FACILITY: Fermi 2

SUBJECT: SUMMARY OF MAY 20, 1981 OL REVIEW MEETING REGARDING MARK I  
CONTAINMENT STRUCTURAL ANALYSIS

EDISON/NRC MEETING - 5-19-81  
EF-2 TORUS MODIFICATION PROGRAM

FIGURE 1  
PRELIMINARY MITERED JOINT SADDLE DESIGN

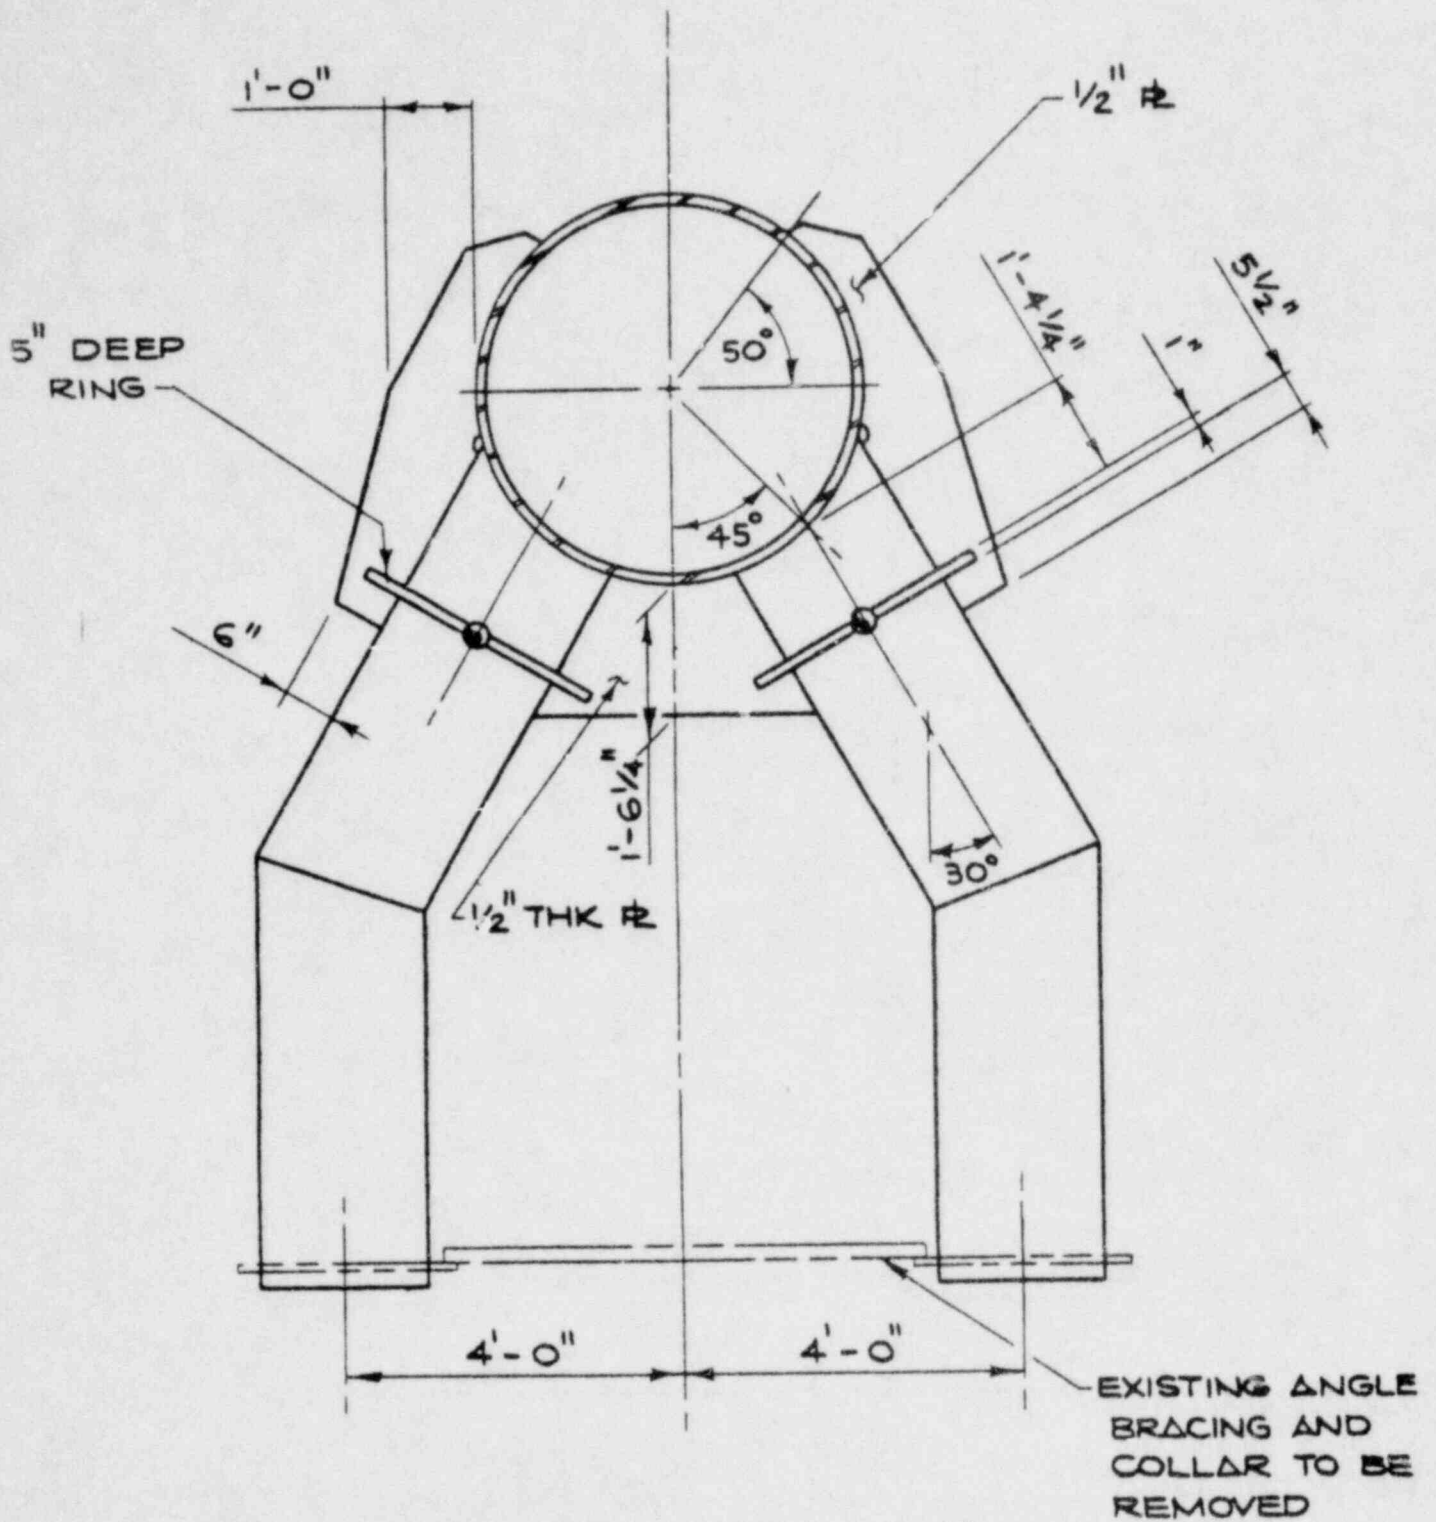
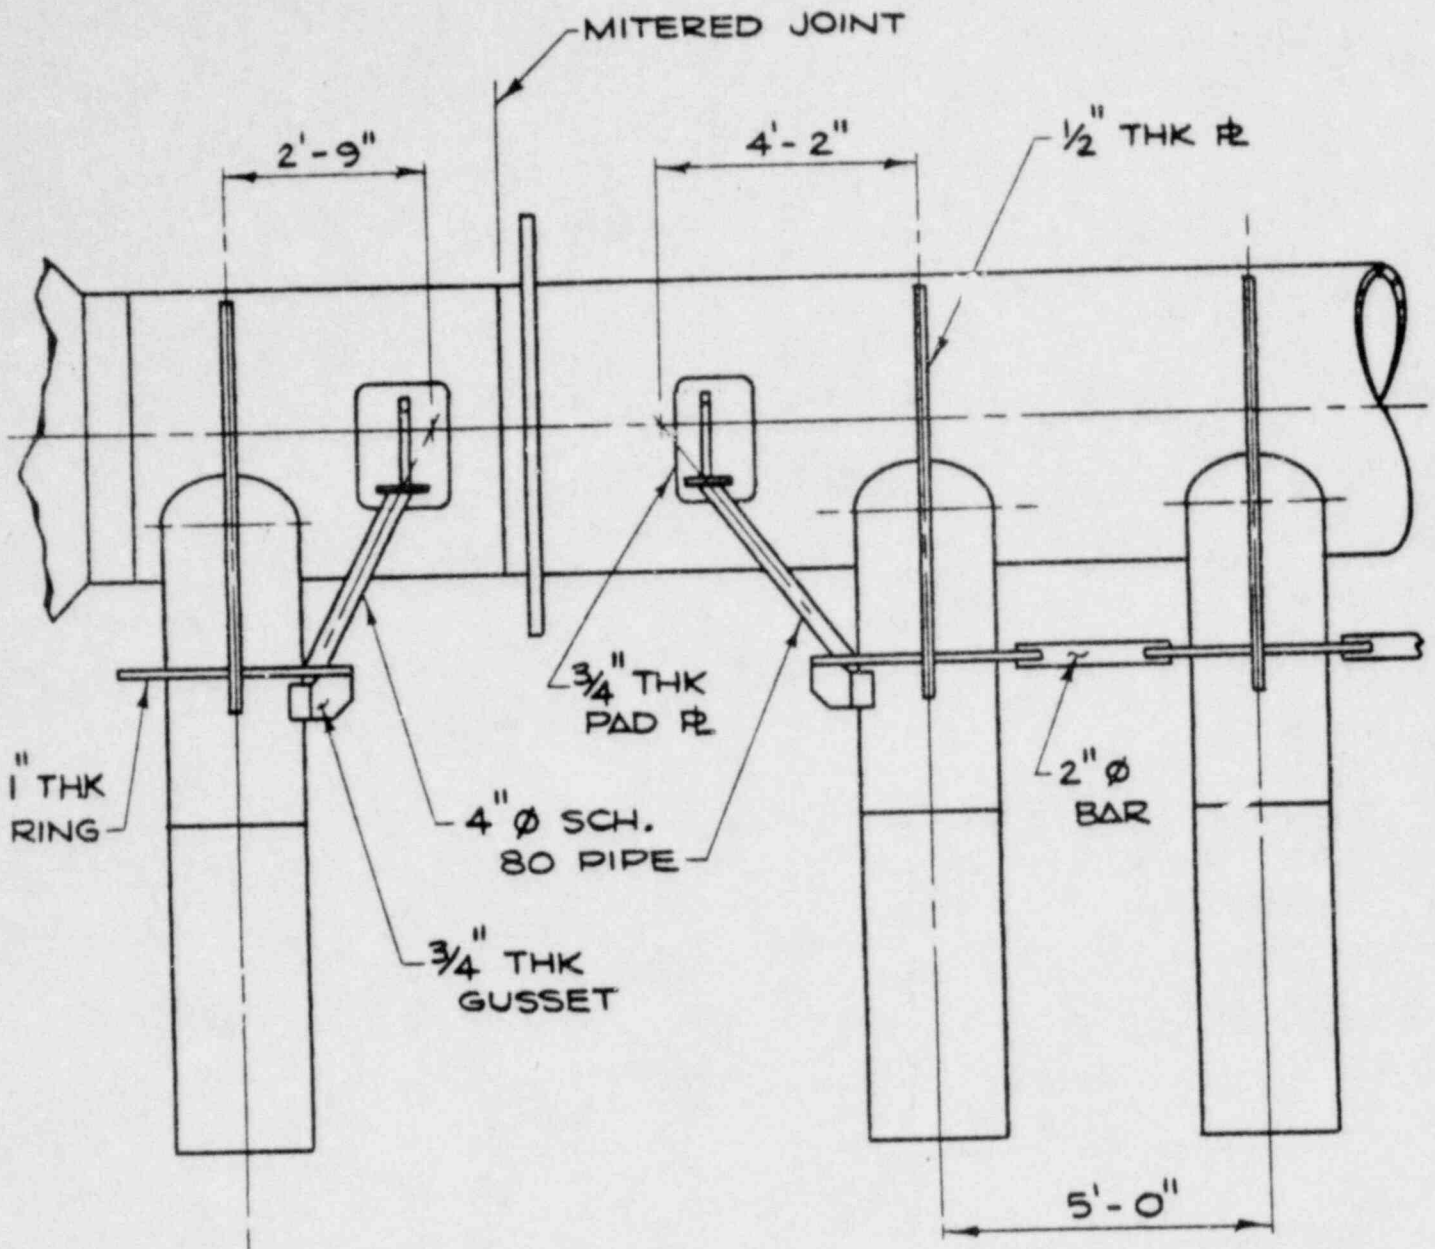
The applicant had submitted an interim Plant Unique Analysis (PUA) that did not consider the condensation oscillation load prior to the issuance of staff's load definition report (NUREG-0661). The current calculations as presented in the meeting include the condensation oscillation load and its effects on the containment. A mitered joint saddle structure has been added to the torus to accommodate the condensation oscillation load. The saddle structure is welded to the torus and bolted to the basemat. (See page 10 of Enclosure)

The staff requested that the results of the current interim PUA analysis as presented in the meeting be submitted by the end of May 1981, including a comparison of loads and criteria with those in NUREG-0661. Staff also requested that a fatigue analysis of safety/relief valve discharge piping in the air space of the wet well be made.
